REGULAR MEETING OF THE DESIGN REVIEW BOARD

4. Public Hearing – El Dorado Townhomes

Request: Design Review Board consideration of a Design Review application for a 29-unit townhome project on a 36,590 square foot parcel in the RM zoning district (ECMC Chapter 19.38).

At the November 2, 2016 Design Review Board meeting, the Board made several comments regarding the project. Those comments and the applicant's response are summarized below.

**HORIZONTAL WOOD FENCE
W/KICKERBOARD** SCALE: 1/2" = 1'-0"
024 - Final

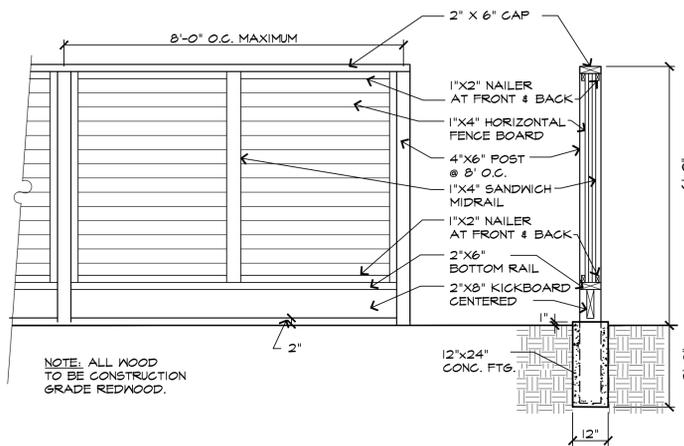
Comment: Use horizontal board fencing along the property line with Central Park.

Response: The fencing has been changed to horizontal board in this location.

INTEGRATED ENTRY DOOR FEATURES
3/4" = 1'-0"

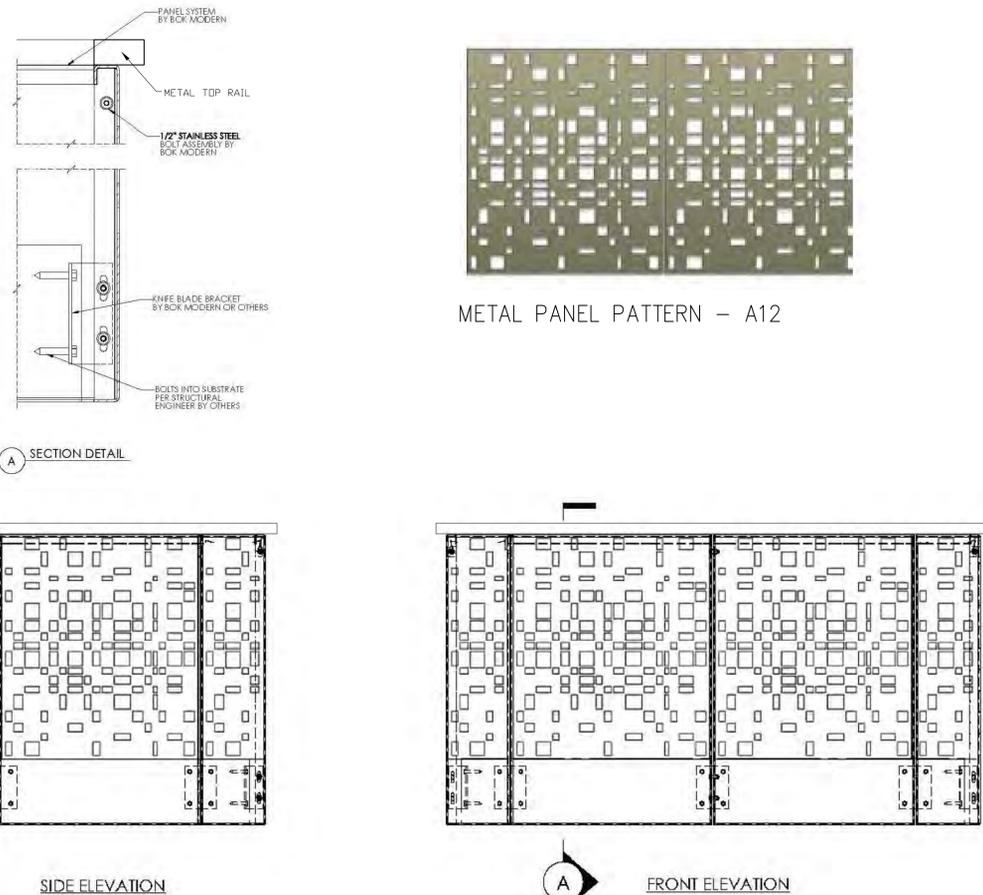
Comment: Add an architectural canopy above the front unit entries.

Response: Many front entries are situated under 2-foot overhangs of the above second story. However, on the Avila Street elevation, several entries do not have an overhang. In these locations, a canopy has been added. In addition, the applicant has added an elevation detail of an entry, showing typical lighting, and address numbers on Sheet A-18.

20 BOK MODERN FASCIA MOUNT GUARDRAIL SYSTEM
NOT TO SCALE

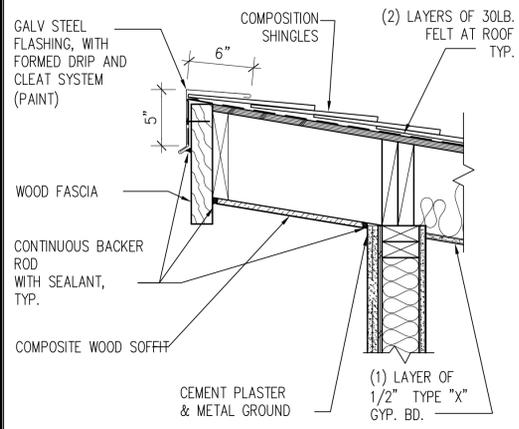
Comment: Use an alternative balcony railing with a more modern look and a top railing.

Response: The railing has been changed to a more modern perforated metal panel (Bok Modern fascia mount guardrail system) with a top railing. A detail of the railing has been provided on Sheet A-18. In addition, the metal railing has been brought down to the bottom of the balcony deck fascia in order to minimize the trim band between stories (see comment below).
